Access Compliance Report

Public Rights-of-Way (Curb Ramps)

Intersection ID: 31723	Main Street: FILBERT_LN	Cross Street: GOLDENWILLOW_DR	Location: SW
ADA ID: A205DE1E7D81	Ramp Type: Perp	Initial Pass/Fail: Fail	Overall Compliance: No
			Severity Score: 21.25

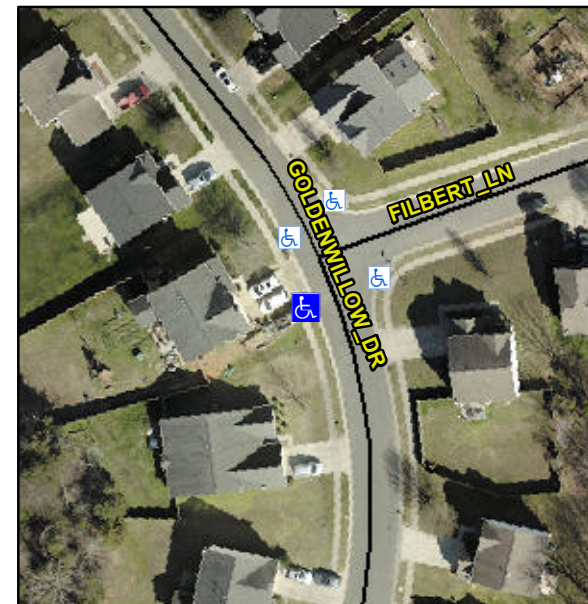
Not Found, R304.5.1, R304.5.3

Compliance	Description	Data	Compliance	Description	Data
N/A	Ramp Length (in)	48.0	Yes	Ramp Slope (%)	5.2
No	Ramp Width (in)	46.5	No	Ramp XSlope (%)	5.2
N/A	Flare Type LT	N/A	N/A	Flare Type RT	N/A
N/A	Flare Slope LT (%)	N/A	N/A	Flare Slope RT (%)	N/A
N/A	Flare Traversable LT?	N/A	N/A	Flare Traversable RT?	N/A
N/A	Landing Length (in)	N/A	N/A	DWS Provided?	N/A
N/A	Landing Width (in)	N/A	N/A	DWS Contrast?	N/A
N/A	Landing Slope (%)	N/A	N/A	DWS Length (in)	N/A
N/A	Landing X Slope (%)	N/A	N/A	DWS Full Width?	N/A
N/A	Landing Curb? (Y/N)	N/A	N/A	DWS Offset (in)	N/A
N/A	Shared Landing?	N/A			
N/A	Gutter Ponding?	N/A	N/A	Gutter Slope (%)	N/A
N/A	Gutter Lip Ht (in)	0.5	N/A	Gutter X Slope (%)	N/A
N/A	Painted X Walk1?	No	N/A	Painted X Walk2?	N/A
	X Walk 1 Direction	To NE		X Walk 2 Direction	N/A
N/A	X Walk 1 Width (in)	N/A	N/A	X Walk 2 Width (in)	N/A
	X Walk 1 Slope (%)	4.3		X Walk 2 Slope (%)	N/A
	X Walk 1 X Slope (%)	5.6		X Walk 2 X Slope (%)	N/A

Remove & Replace Entire Ramp.
